CUSTOMER NOTICE OF PRODUCT/PROCESS CHANGE

CTS Part Number: 223AJVAAR, 223AJVABR, 223AMVAAR, 223AMVABR

CTS Product Series: 223A, See Part Listing above

Figure 1: Housing injection molding location change

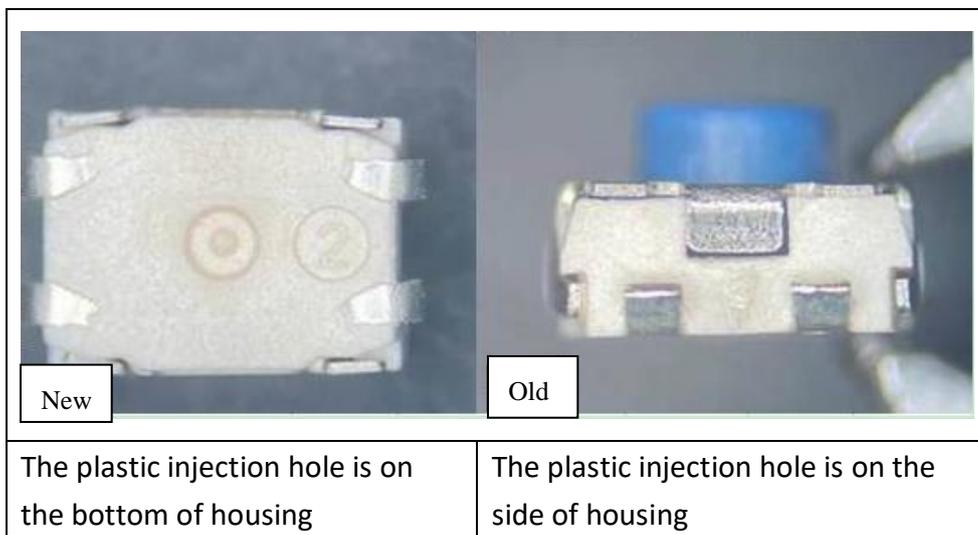
Description of Change: Housing component – Plastics mold injection location moved from side surface to bottom surface.

Reason for Change: Injection point in the mold changed to enhance the production efficiency and yield of housing component.

3. Comparisons of the housing can be seen in Figure 1.

Implementation Date: Shipments with the revised housing will start 23 August 2021

Notes: 1. Changes are cosmetic and will not change the fit, form or function of the 223A Switch.
